POWERTECH (USA) INC.

**Re: Powertech (USA) Inc.'s Supplemental Sampling Plan and Responses to Comments
Regarding Draft License SUA-1600; Dewey-Burdock Project; Docket No. 40-9075; TAC No. J
00606**

Supplemental Preconstruction and Preoperational Sampling Plan Dewey-Burdock Project

Responses to Comments on the Draft License Conditions and Public Meeting of August 30, 2012

Figure 2

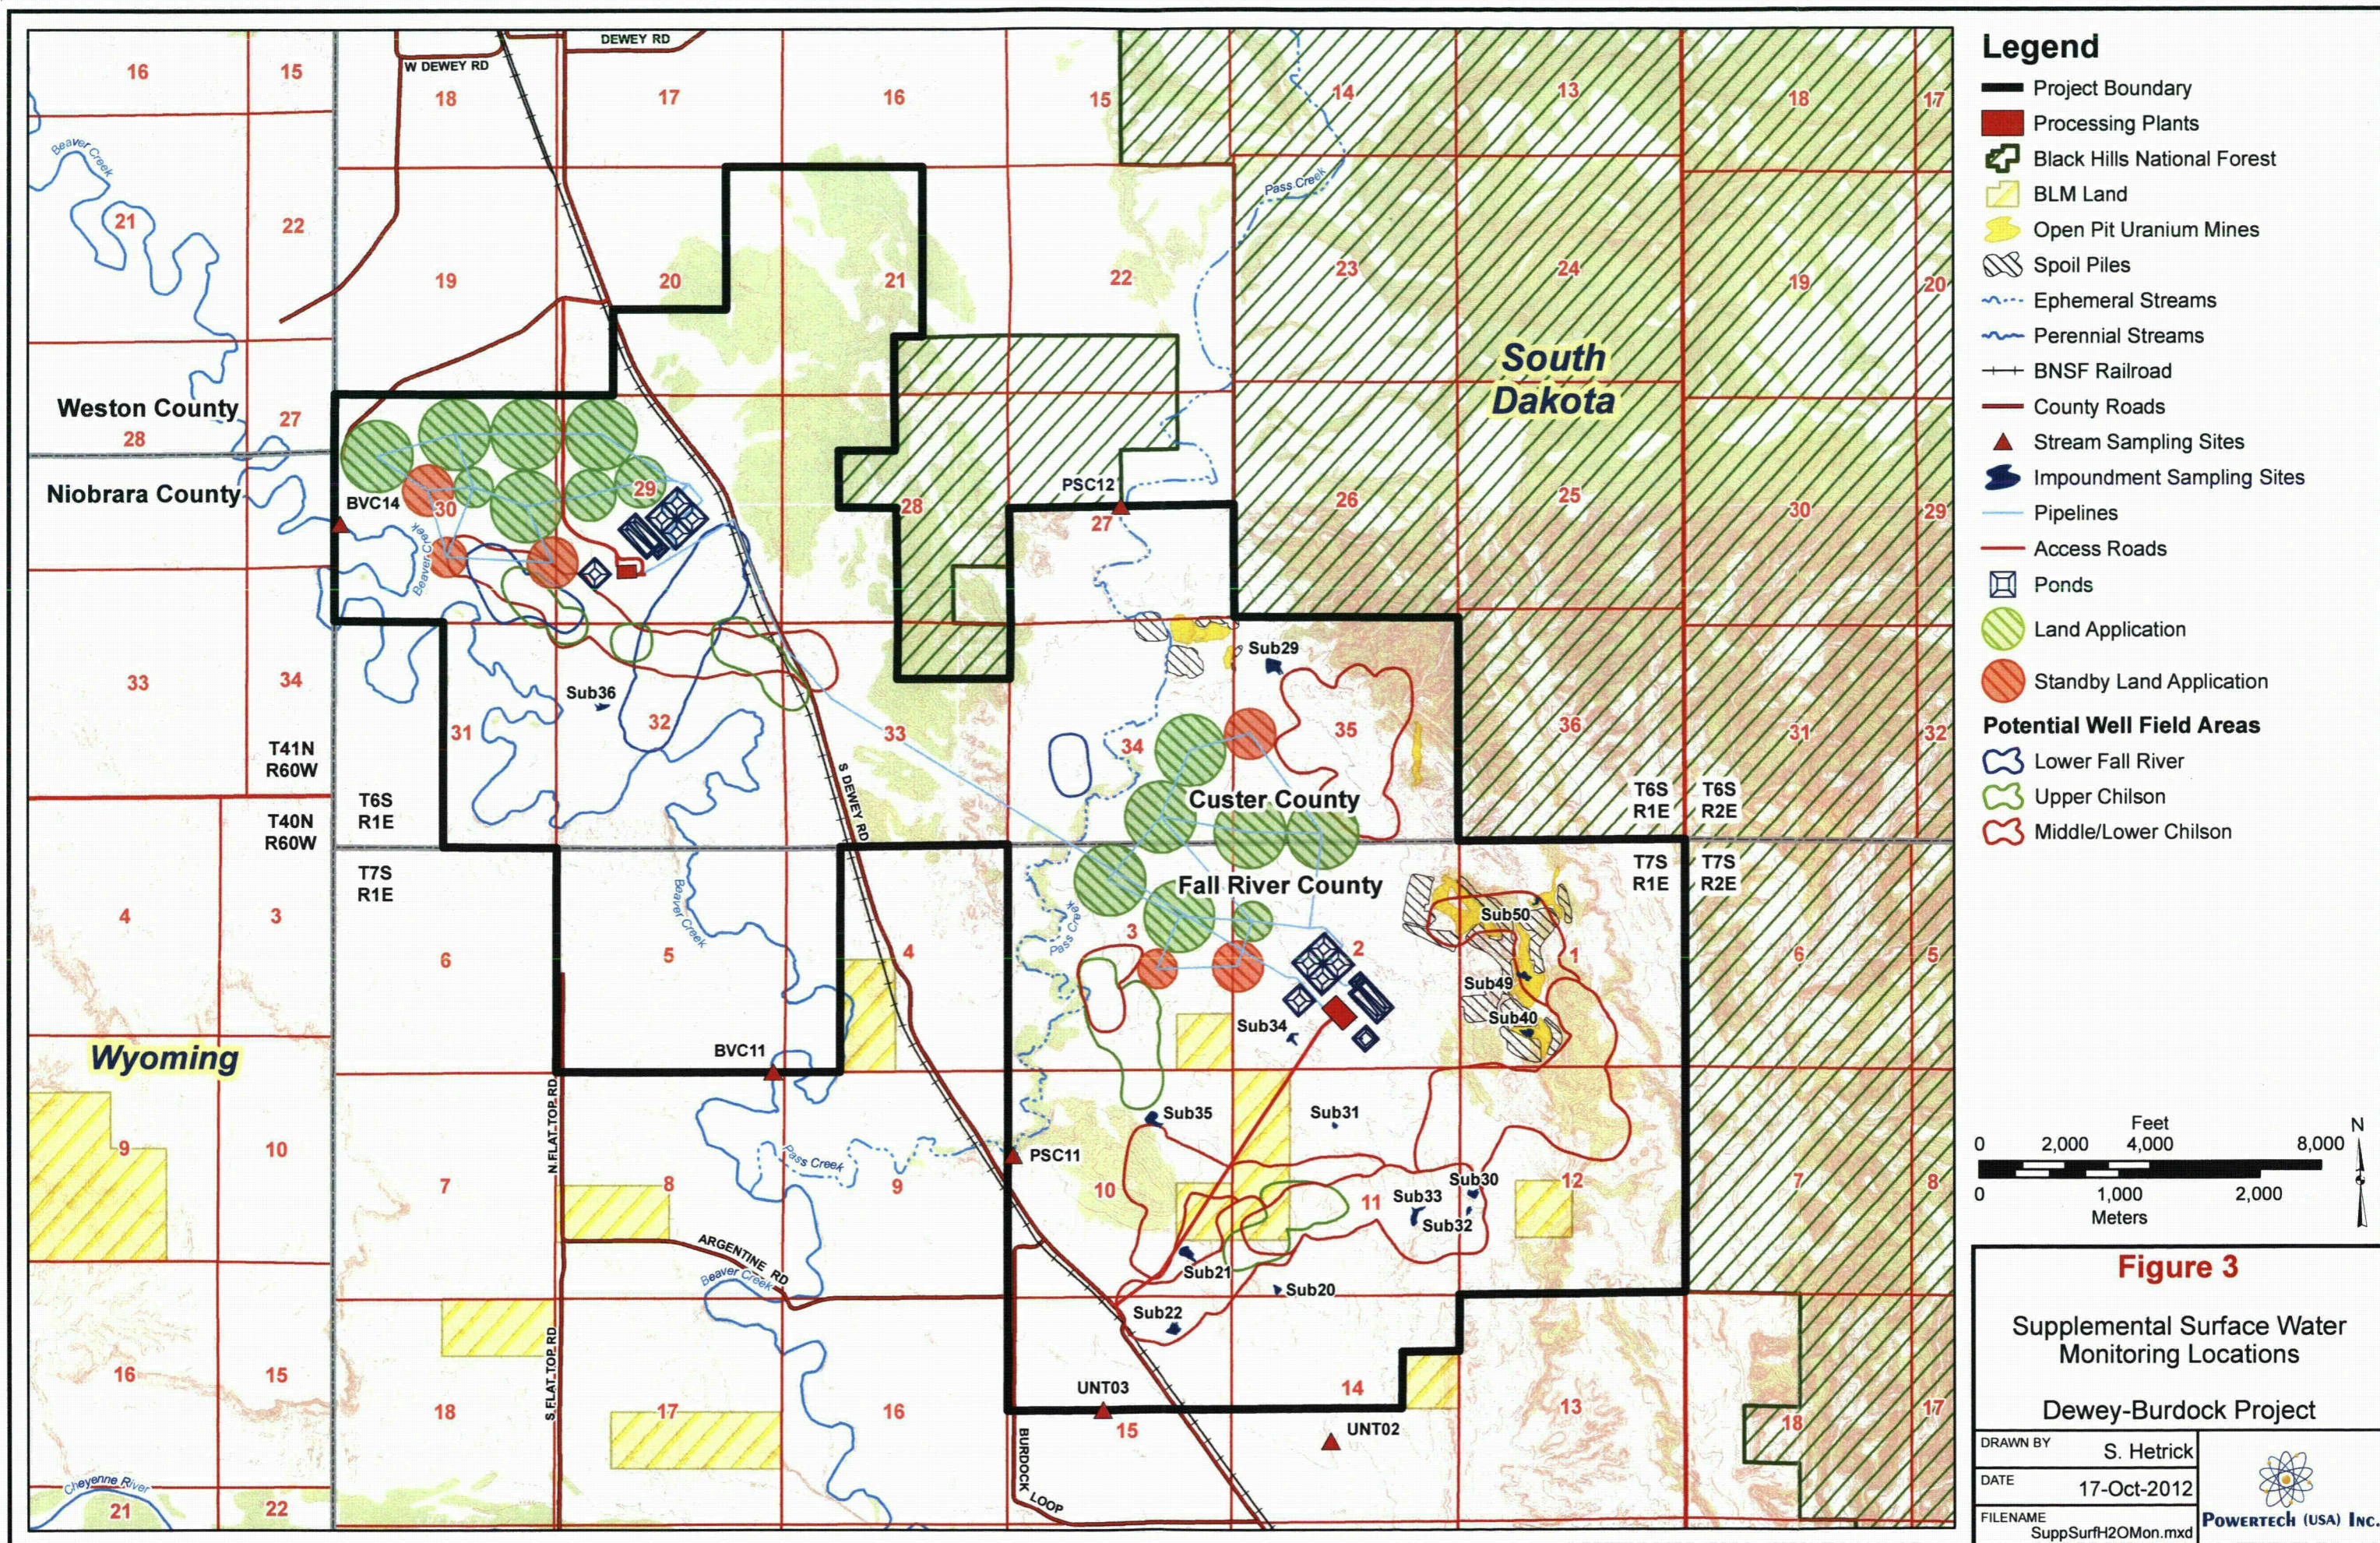
Supplemental groundwater sampling locations are shown on Figure 2, enclosed. Analyses will be performed to meet LLDs and analytical reporting formats specified in RG 4.14. Results will be provided to NRC for review and written verification.

Figure 3
 Supplemental Surface Water
 Monitoring Locations
 Dewey-Burdock Project

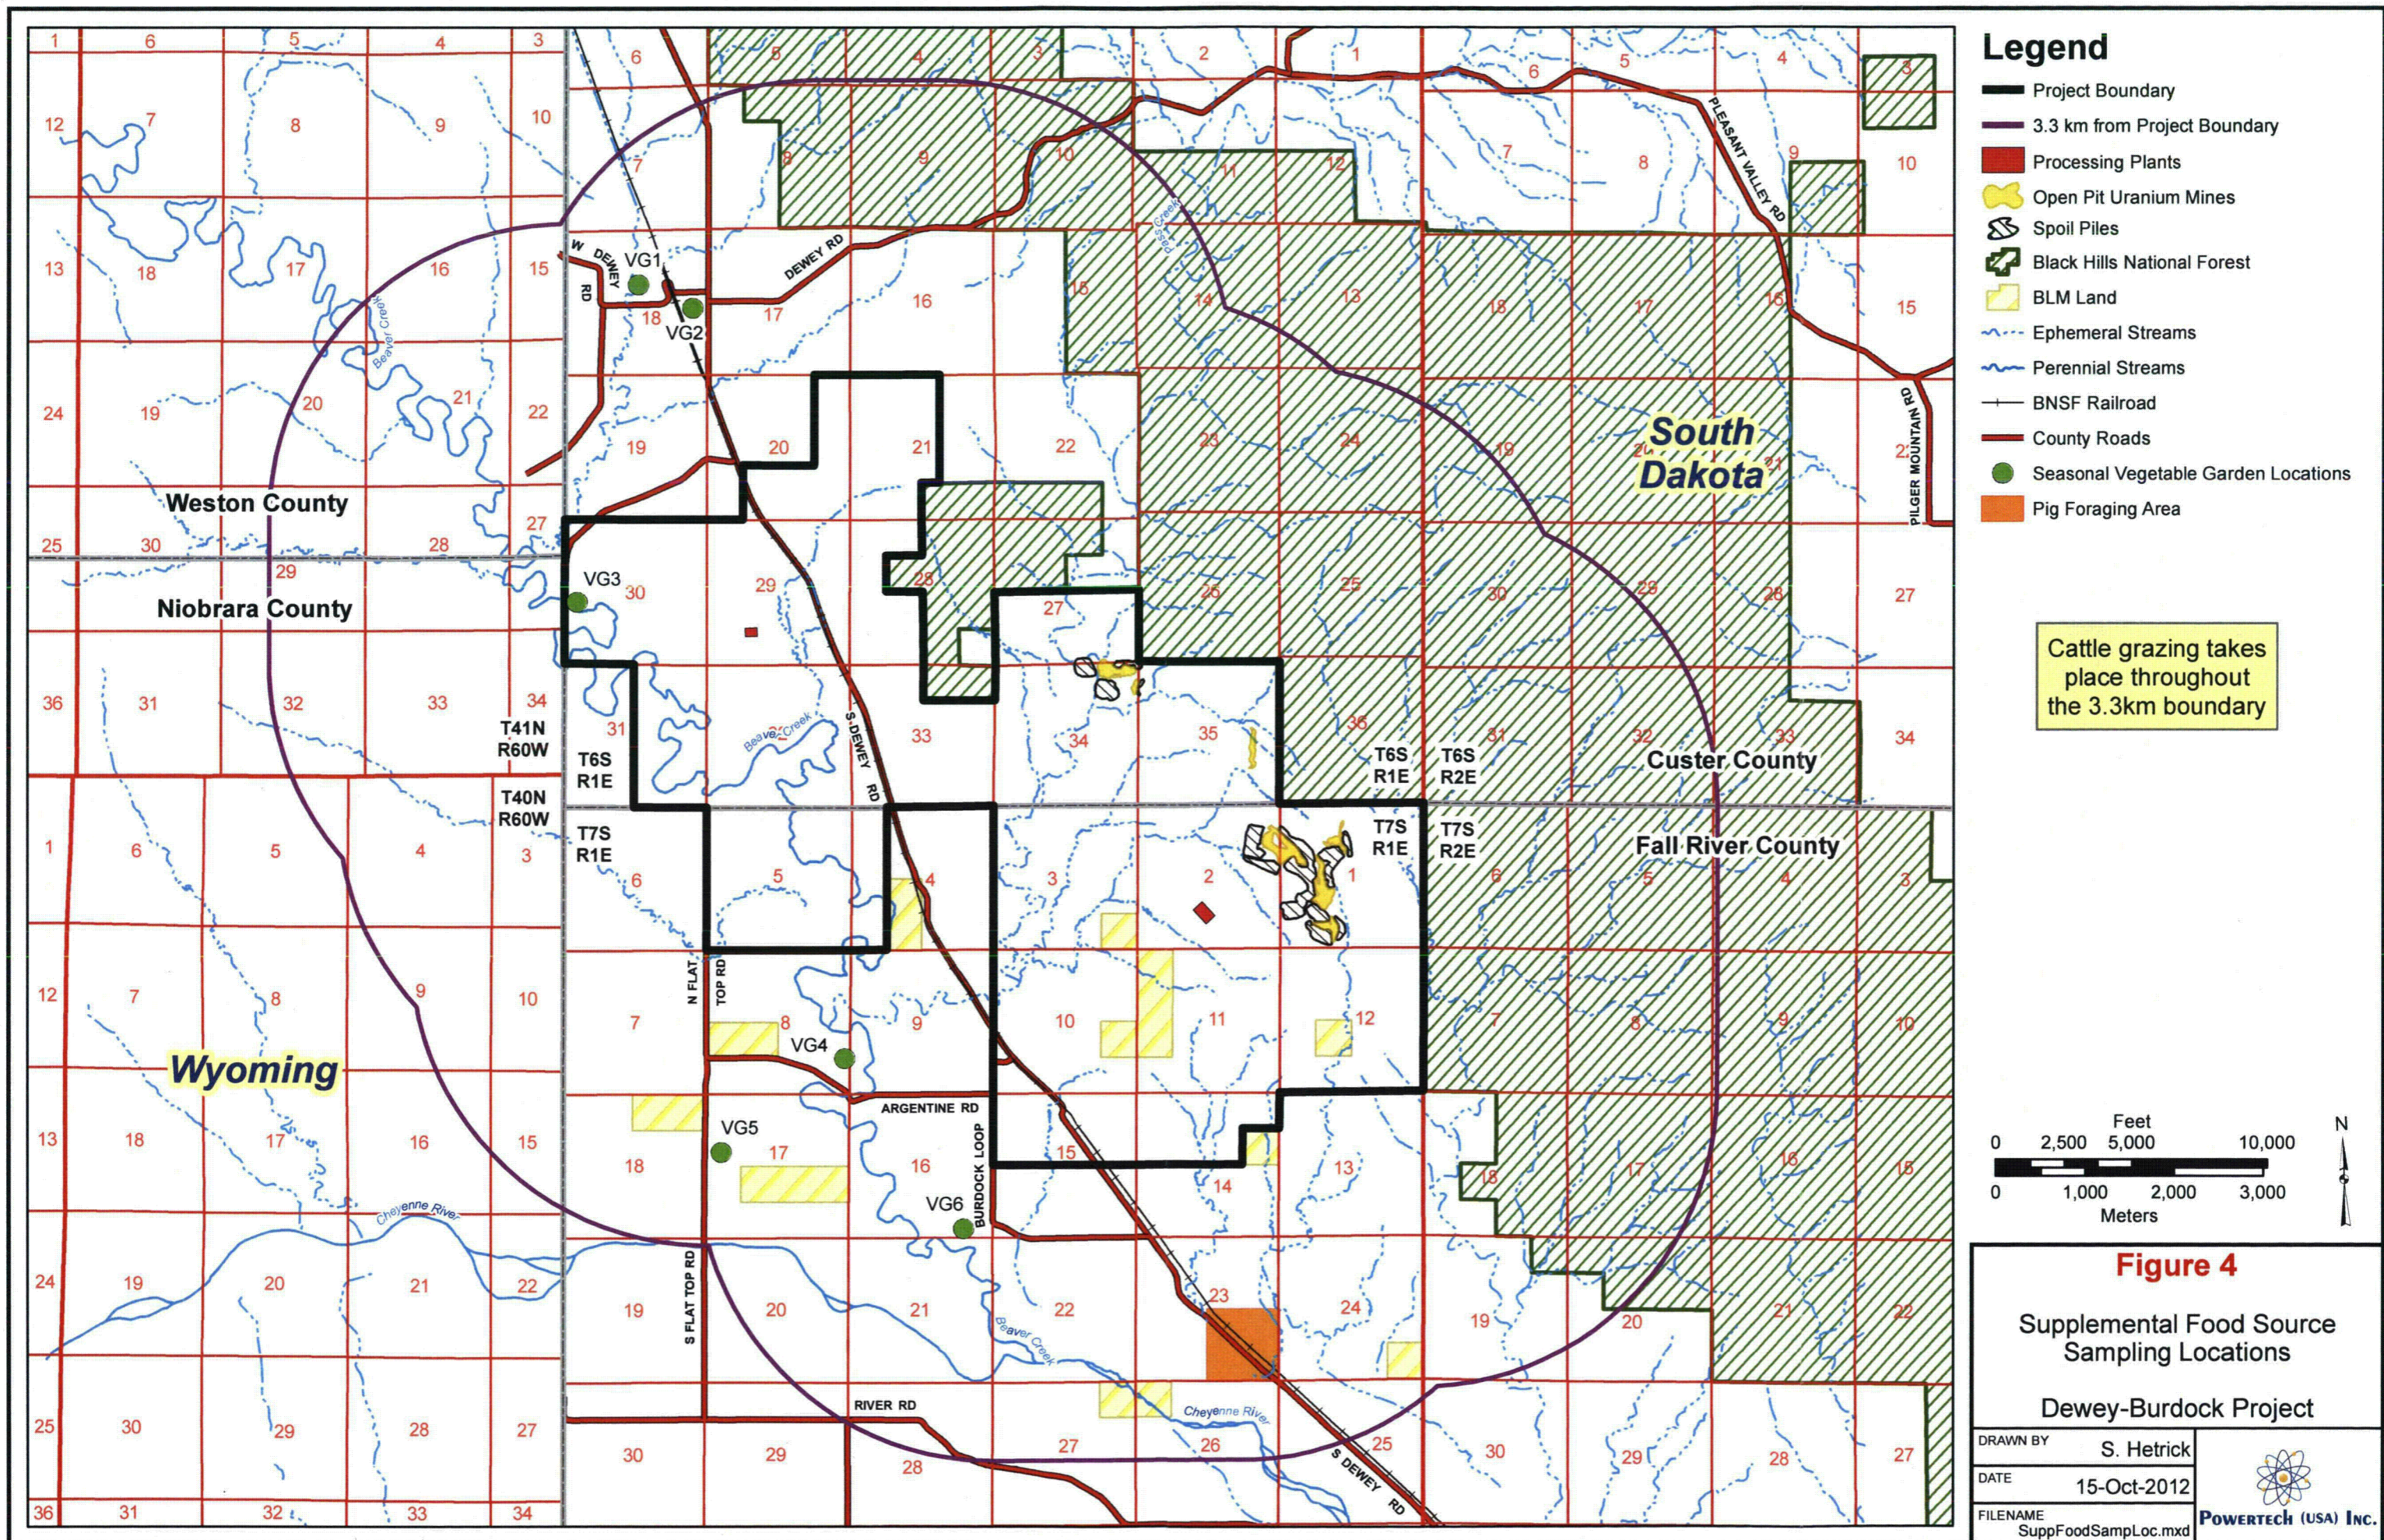
Supplemental surface water sampling locations are shown on Figure 3, enclosed. Sediment sampling locations coincide with surface water sampling locations. Analyses will be performed to meet LLDs and analytical reporting formats specified in RG 4.14. Supplemental surface water sample results will be provided to NRC within 3 months of initiating operations. Supplemental sediment sample results will be provided to NRC at least 30 days prior to operation.

Figure 5

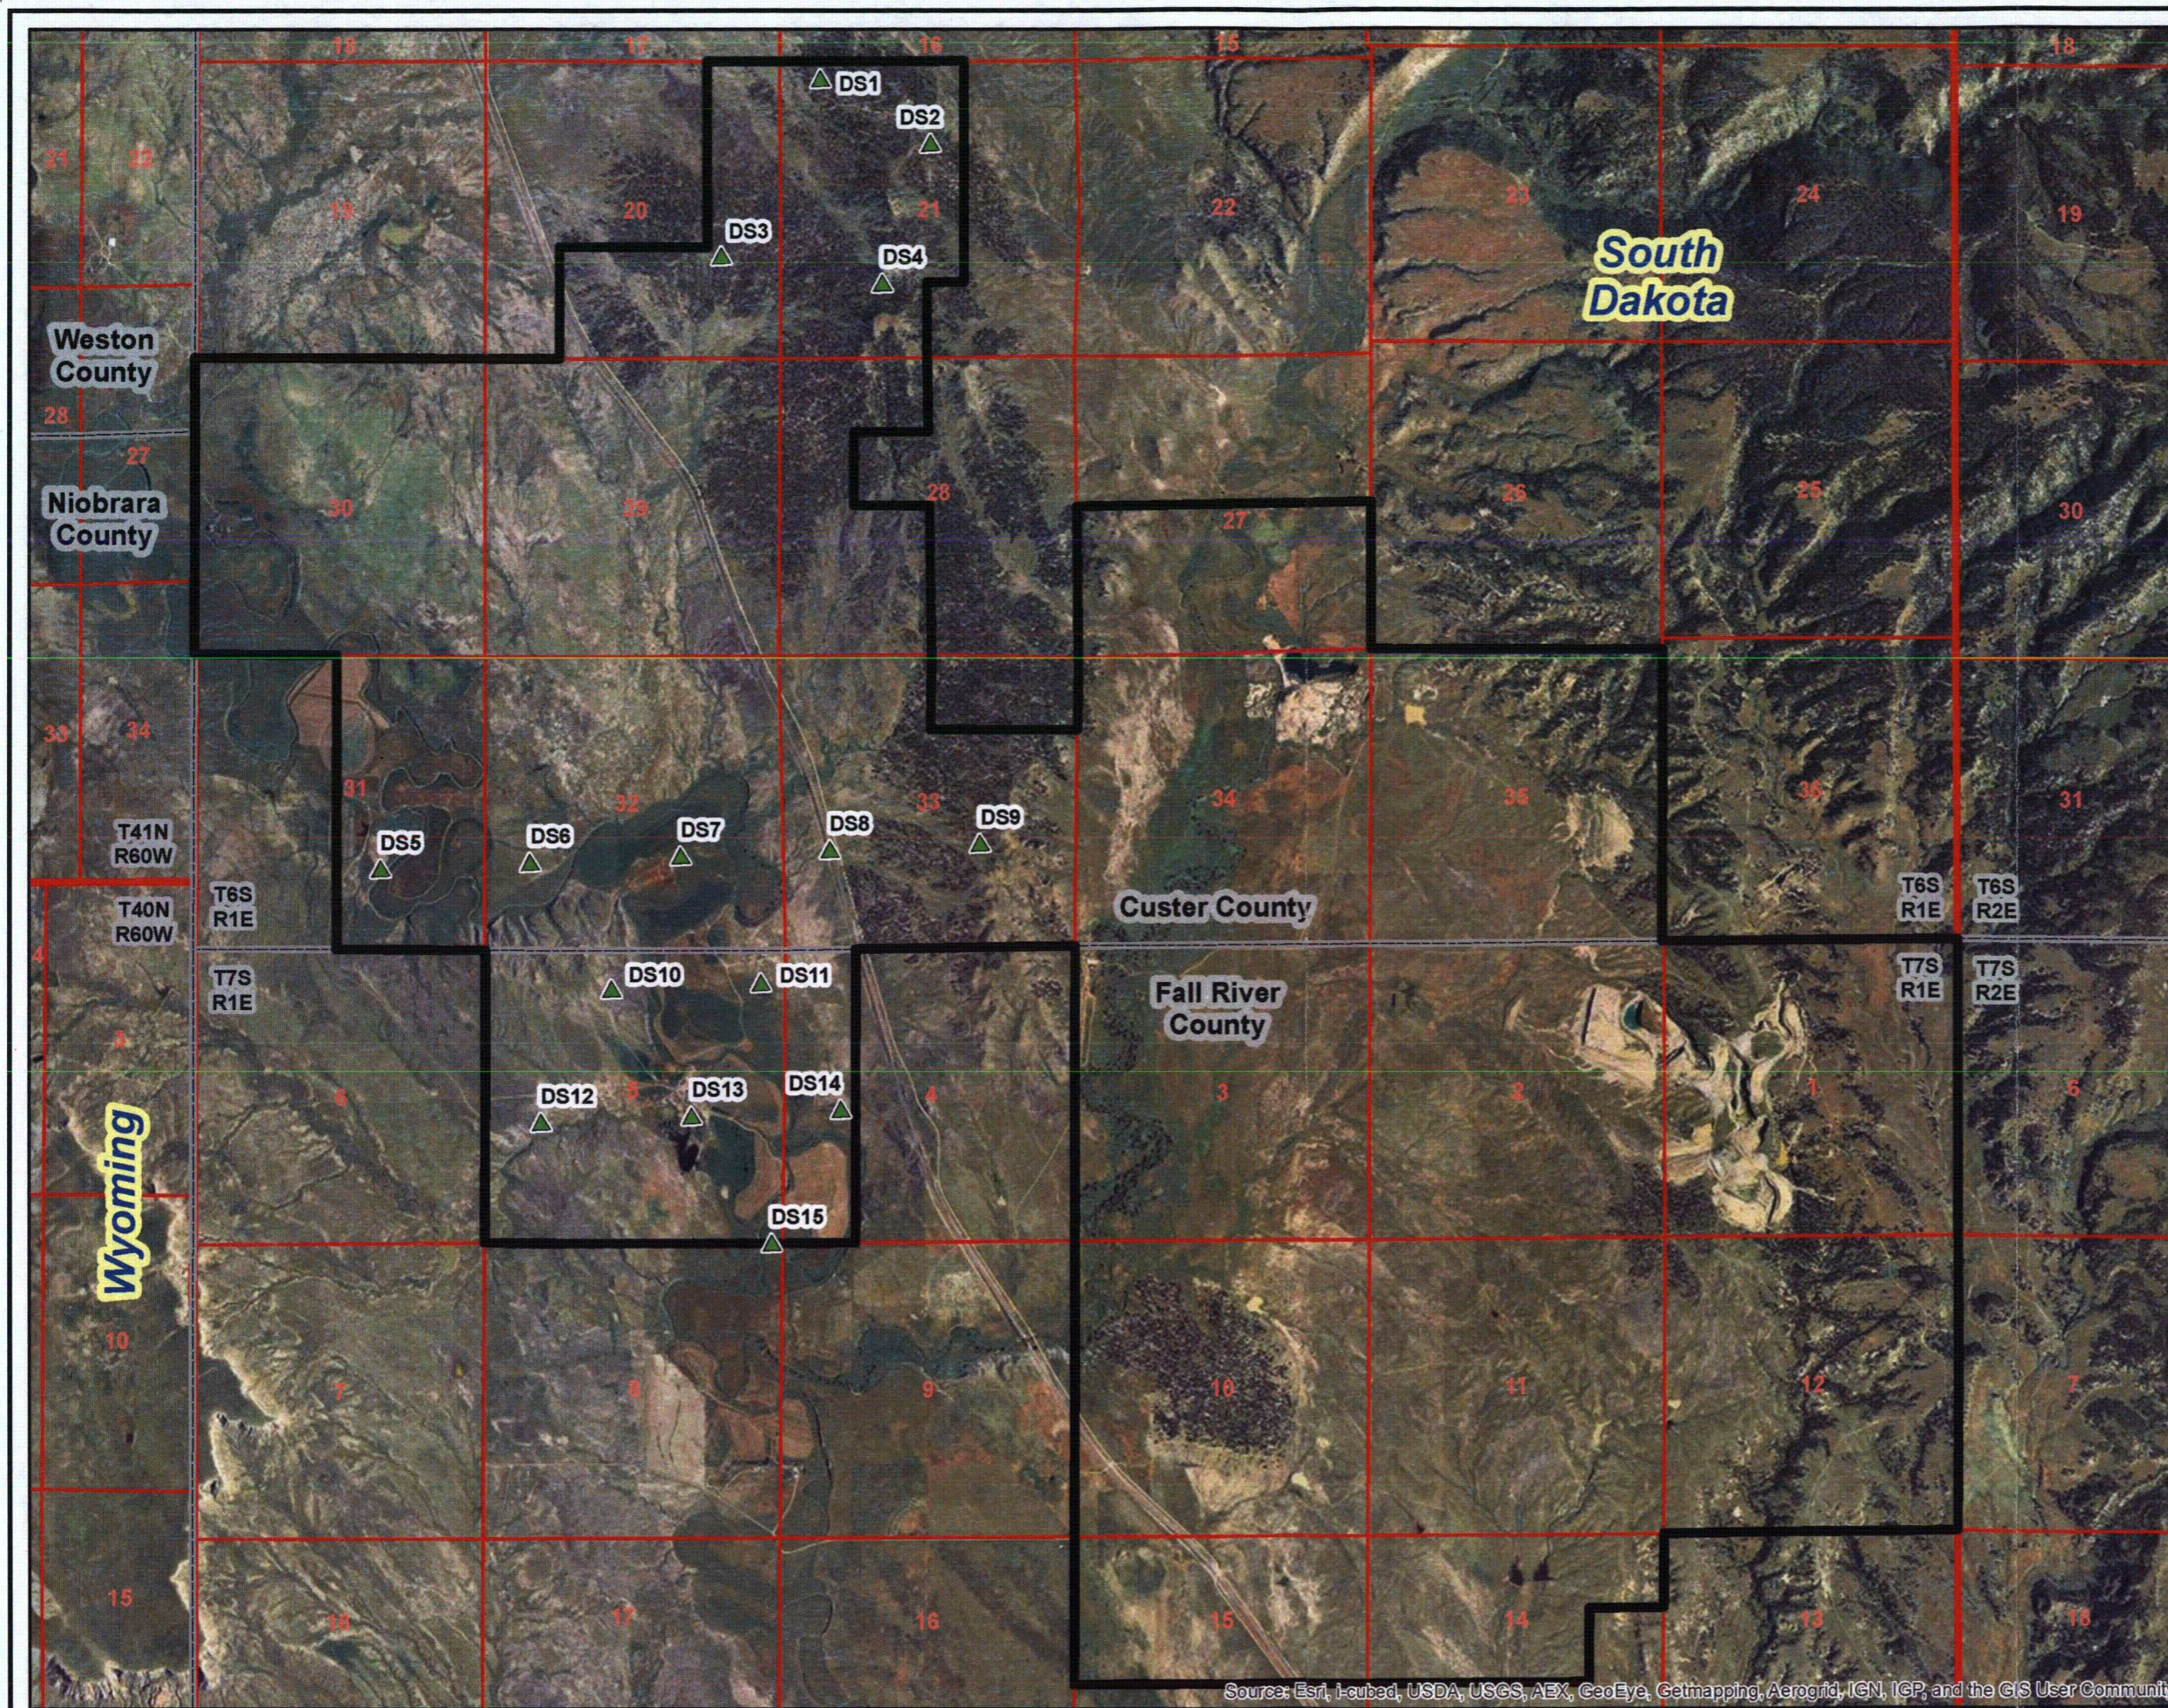
- Fifteen supplemental surface soil samples (0 to 15 cm) will be collected in the Dewey portion of the project area to more closely match the soil sampling density applied across the Burdock portion of the project area. Supplemental soil sampling locations are shown on Figure 5, enclosed.
- One surface soil sample (0 to 5 cm) will be collected at AMS-08 and AMS-09, the locations of which are shown on Figure 1.
